TOWN OF COTTESLOE

BEACH ACCESS PATH COMMITTEE MINUTES

MAYOR'S PARLOUR, COTTESLOE CIVIC CENTRE
109 BROOME STREET, COTTESLOE
1.00PM, MONDAY, 15 JANUARY 2018

BEACH ACCESS PATH – ENDORSEMENT OF CONCEPT DESIGNS FOR THE PURPOSE OF COMMUNITY CONSULTATION

Beach Access Path S10

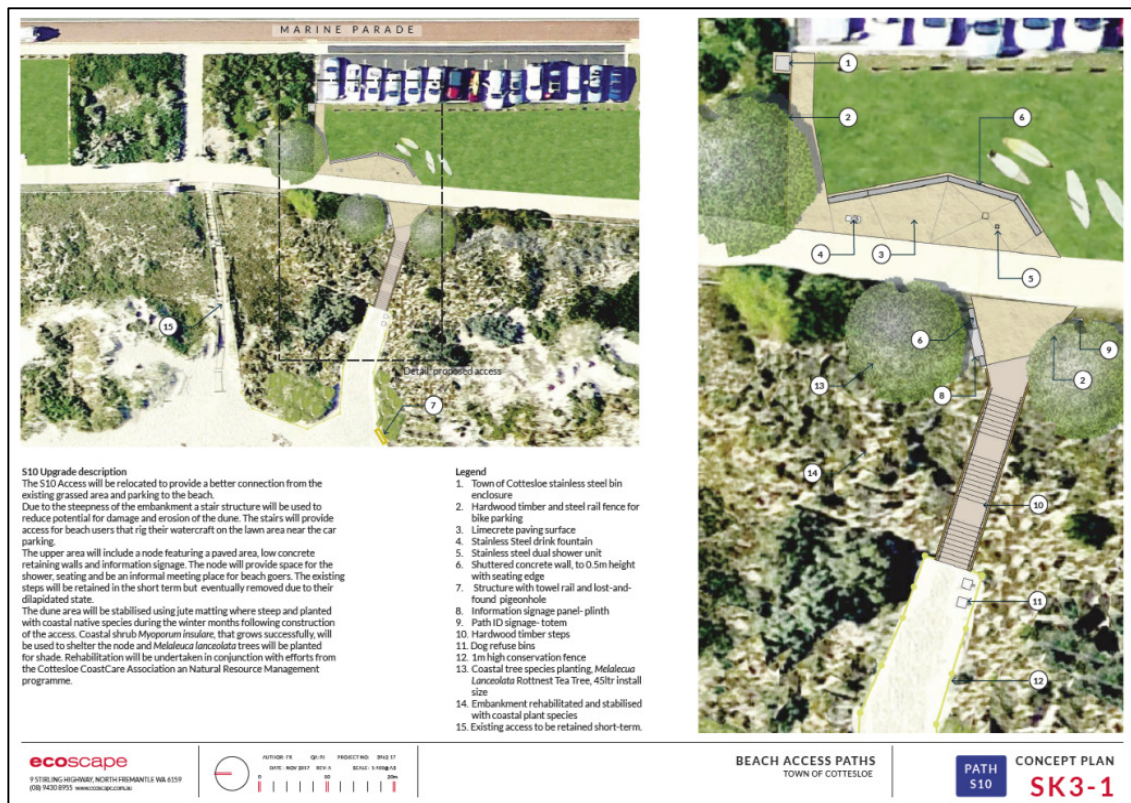
Cr Boulter raised questions regarding no. 6, Shuttered Concrete Wall, to 0.5m height with seating edge. In particular, why concrete was chosen over limestone, the comparison in costs, durability and whether concrete is a suitable surface to sit on. Mr Kotai explained that cost is fairly comparable and durability is good. Mr Kotai used Bathers Beach House in Fremantle as an example, as the walls are made to a smooth finish which is suited to seating.

Mr Ewing advised the Committee of an issue with the shower drain at S10. There is a build up of sand and the drain gets blocked. Mr Kotai advised the Committee of subsurface drainage above the sand dune line and that the excess sand should be dispersed rather than being dumped in one spot. Cr Boulter advised the Committee that this is also a health risk as the blocked drain creates a pool of water which is then stood in by beachgoers. Cr Pyvis suggested this is both a design and management issue. Cr Pyvis showed the

Committee a picture of the erosion that occurred at the Water Corporation fountain at Dutch Inn. Cr Boulter informed the Committee that water from the shower at S10 might blow into cyclists/pedestrians on the footpath.

Cr Boulter asked the Committee how cyclists and pedestrians can be warned that they are entering a busy area, and encourage them to slow down. Mr Kotai advised the Committee that this can be effectively done by painting on the shared path, alerting cyclists/pedestrians on their approach, rather than a bollard. Mr Kotai used City of Perth as an example. Cr Boulter suggested coming up with an example for the next meeting and marking up the concept plans.

Cr Boulter asked Mr Kotai whether trees have been incorporated into the plan. Mr Woodhouse pointed out that S10 has three *Melaleuca Lanceolata* Rottneest Tea Trees illustrated for planting. Mr Kotai advised the Committee that this species is well-suited to coastal dune areas and will provide shelter as a windbreak. Mr Woodhouse advised the Committee that the intention is to keep vegetation on the beach side of the dune and keep the grassed area clear for better connection. Mr Woodhouse advised the Committee that a Town water truck would help establish the trees. Mr Ewing supported the choice of tree species and suggested that as well as providing shelter the trees could be seen as an aesthetic barrier. Mr Ewing was also in support of no. 12, 1m high conservation fence, as long as the design is kept minimal. Cr Boulter asked Mr Kotai whether no. 10, Hardwood timber steps, would be open underneath or supported by wire. Mr Kotai advised the Committee that there would be a wire mesh following the balustrade to stop dogs from going off the path.

- Delete no. 11, Dog refuse bins
- Minimal seating
- A dog drink bowl be incorporated into every shower unit
- Noted inclusion of drinking fountain
- Mark up concept plans with proposed footpath “slow down” signage
- Maximise green space
- Keep design of no. 12, 1m high conservation fence minimal

Beach Access Path S12

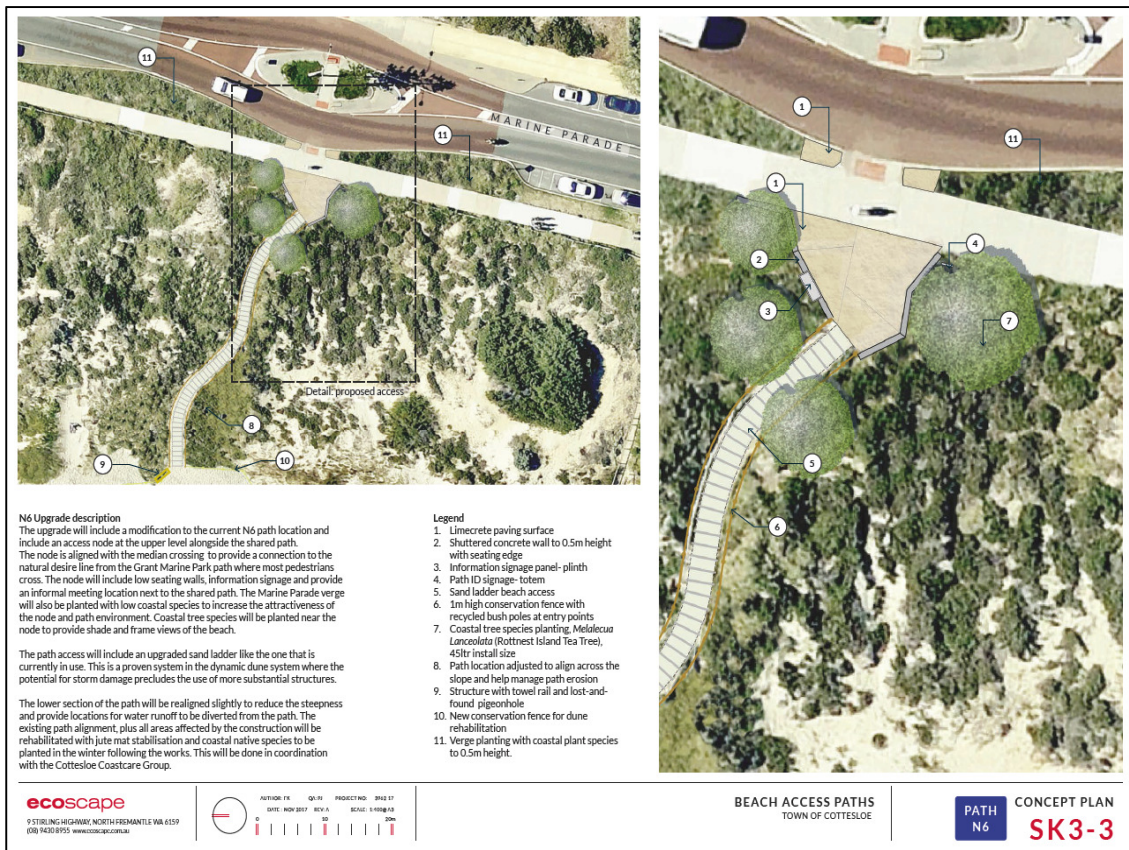
Similarly to S10, Cr Pyvis suggested improved labelling and including an inset map to show the closest streets to S12 so the community can identify the location of the path. Mr Kotai advised the Committee of the description to remove seven car parking bays that will be replaced by a grassed area. Cr Boulter suggested marking up the map with the areas where parallel car parking bays will be gained along Marine Parade.

Cr Pyvis raised the issue of cars overhanging on the footpath, particularly people loading/unloading beach equipment. Mr Kotai advised the Committee that the standard car parking bay length is 5.5m. Mr Kotai advised the Committee that spaces with an overhang into adjacent landscaped areas may be reduced to 4.8m to create more footpath. Mr Kotai suggested avoiding wheel stops because they can be a trip hazard. The Committee discussed the option of either signage in the car parking bay to alert drivers to park in forward, or a sign to alert pedestrians/cyclists to be mindful of car doors/boots opening. Cr Boulter asked Mr Woodhouse to find a suitable solution for the next meeting.

Cr Boulter addressed the signage outlined in the plan and whether there is signage for emergency services. Ms Tyler-Hare advised the Committee of BEN signs which is a beach numbering system to help emergency services locate the scene of emergencies more quickly. City of Mandurah has adopted the system and is encouraging coastal local government areas to get involved. The system is designed to help emergency services find beach access points when called out to respond to an incident. The sign would be a stand-alone sign. The system is not currently legislated, but if it does become legislated the current beach access path numbering system would need to be

Cr Boulter asked Mr Kotai if no. 6, Information signage panel-plinth, included information about the Fish Habitat Protection Area (FHPA). Cr Boulter suggested that the signage for the FHPA be done separately with one side of the sign providing information on regulations (anchors etc.) and the other side with information/pictures on FHPA (weeding sea dragons etc.). Cr Boulter advised the Committee that the current FHPA signage needs replacing. Mr Ewing advised the Committee that the Coastcare signage also needs replacing and any signage needs to be carefully integrated. Cr Pyvis requested the Committee be kept up-to-date with any discussions held at the FPIC on signage.

- Signage that alerts the public they are entering an activity area

Beach Access Path N6

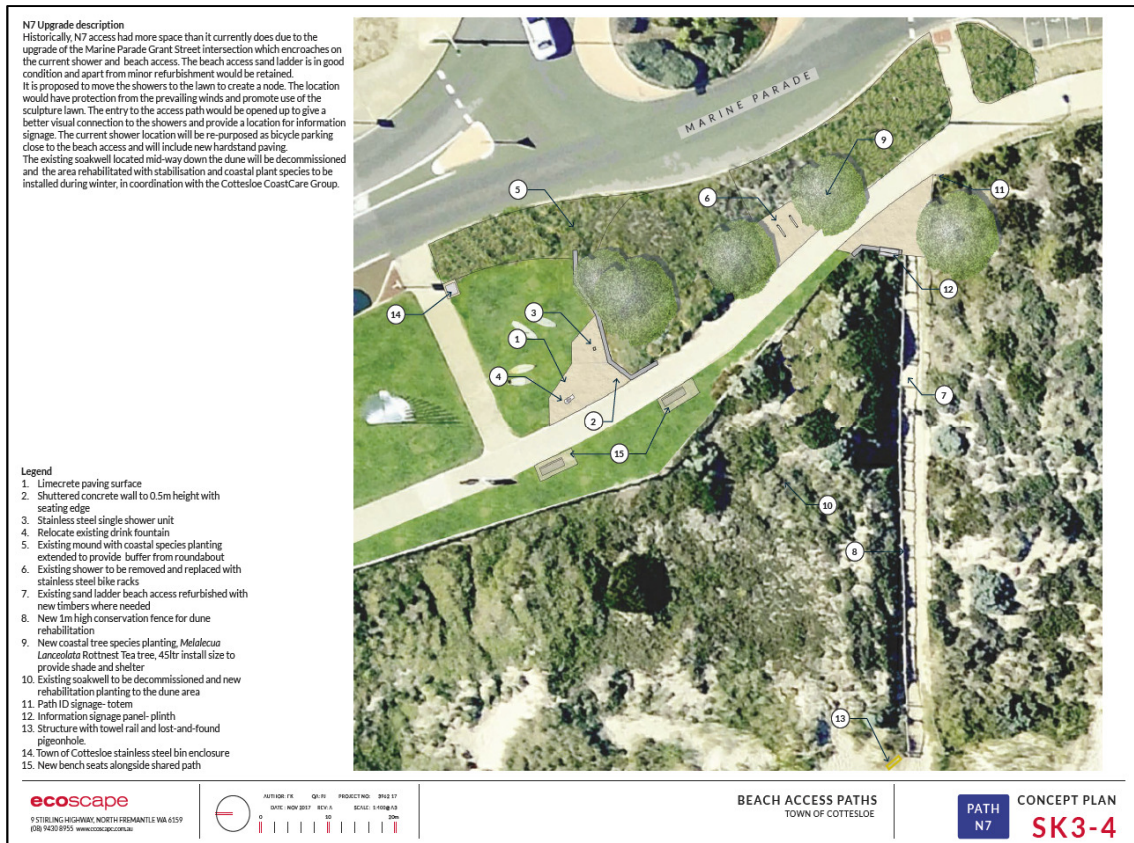
Mr Kotai advised the Committee of the changes to the paved space and the smaller node to increase planting on the Marine Parade verge. There are no changes to the alignment. The stainless steel single shower unit was deleted and moved to N5. Cr Pyvis referred to Ms Woods comments regarding the log ladder at N7 which also relates to N6 no. 5, Sand ladder beach access.

1. N7 appears to be getting a lot more traffic lately as people are parking in Grant St. There are at least 7 logs unattached at the moment so it is in need of urgent repair. Although the old log ladder has coped quite well for over 40 years perhaps now as the usage of this path as increased dramatically, a more substantial access should be considered- or a plan for this down the track. (Perhaps a combination of stairs and log ladder?)

If it is considered that a new log ladder will be adequate then that is fine. I note on the sketch it states to 'MAKE MINOR REPAIRS AS NEEDED'. I believe that the log ladder should be replaced and widened at least.

I want to highlight the dramatic increase in usage. This may be because many have been forced to use this because Nippers take up the rest of the beach on Sundays, or it could possibly be the closure of the N5 path. Whatever it is it is having an impact on the path N7. This may lessen as N6 is improved.

Cr Boulter suggested that the motorcycle parking on Marine Parade be converted to a bike rack. Mr Woodhouse advised the Committee that having a bike rack on the road is not desirable. Cr Boulter asked if there is a way to incorporate a bike rack without losing green space.
